UNITED STATES PATENT AND TRADEMARK OFFICE

APPLICATION NO.	FILING DATE	FIRST NAMED INVENTOR	ATTORNEY DOCKET NO.	CONFIRMATION NO.
10/518,290	12/15/2004	Thomas Duignan	1209-2 PCT US	6672
7590	09/08/2006		EXAMINER	
Dilworth & Barrese 333 Earle Ovington Boulevard Uniondale, NY 11553			RODRIGUEZ, SAUL	
			ART UNIT	PAPER NUMBER
			3681

DETAILED ACTION

This is a first office action on the merits of patent application S. N. 10/518,290.

FIG.2

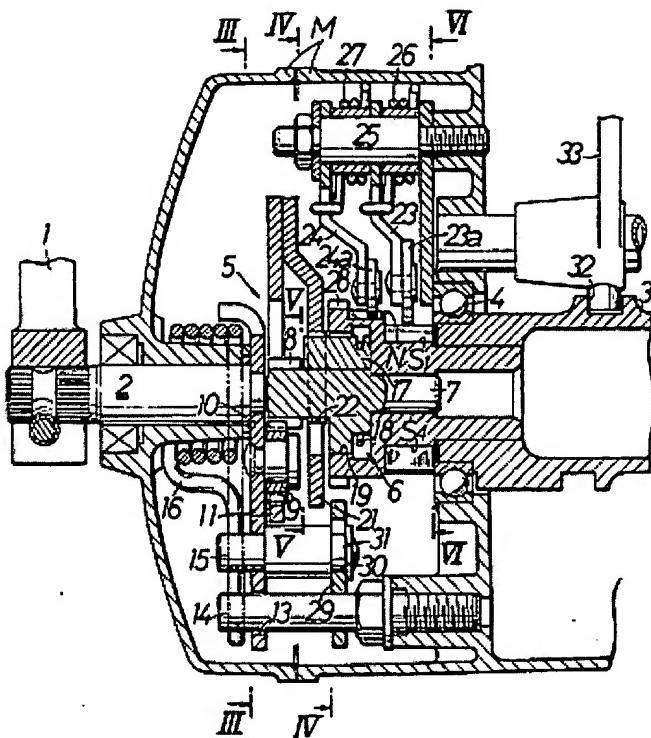
Claims 1-6 and 15-16 are rejected under 35 U.S.C. 102(b) as being anticipated by Tsuboi ('820).

Tsuboi discloses a foot operated gearshift hand operated clutch release unit (Fig. 1) for a motorcycle comprising a pedal (1), a pedal axis (2) with rest and loaded positions, a cam subassembly (Fig. 5), a motion transmitting link (23, 24), a cam (19), a cam plate (3), a plurality of teeth (20), a unitary structure of the cam/cam plate, a ratchet mechanism (17, 17') with a pair of arms, a plurality of angular positions, a pawl-upset pin (31), a pedal return resilient element (16), a pawl return resilient element (22), a shift linkage (32), a crank bell (33), a hand operated clutch lever (Fig. 1).
